**MICROCHIP****PIC18F2515/2610/4515/4610****PIC18F2515/2610/4515/4610 Rev. A4 Silicon Errata**

The PIC18F2515/2610/4515/4610 Rev. A4 parts you have received conform functionally to the Device Data Sheet (DS39636C), except for the anomalies described below. Any Data Sheet Clarification issues related to the PIC18F2515/2610/4515/4610 will be reported in a separate Data Sheet errata. Please check the Microchip web site for any existing issues.

The following silicon errata apply only to PIC18F2515/2610/4515/4610 devices with these Device/Revision IDs:

FIGURE 1: SCK PULSE VARIATION USING TIMER2/2

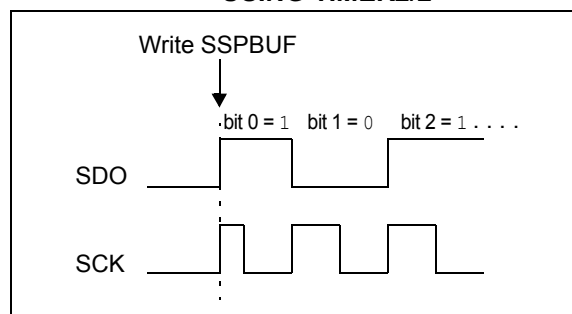
When the SPI is using Timer2/2 as the clock source, a shorter than expected SCK pulse may occur on the first bit of the transmitted/received data (Figure 1).

To avoid producing the short pulse, turn off Timer2 and clear the TMR2 register, load the SSPBUF with the data to transmit and then turn Timer2 back on. Refer to Example 5 for sample code.
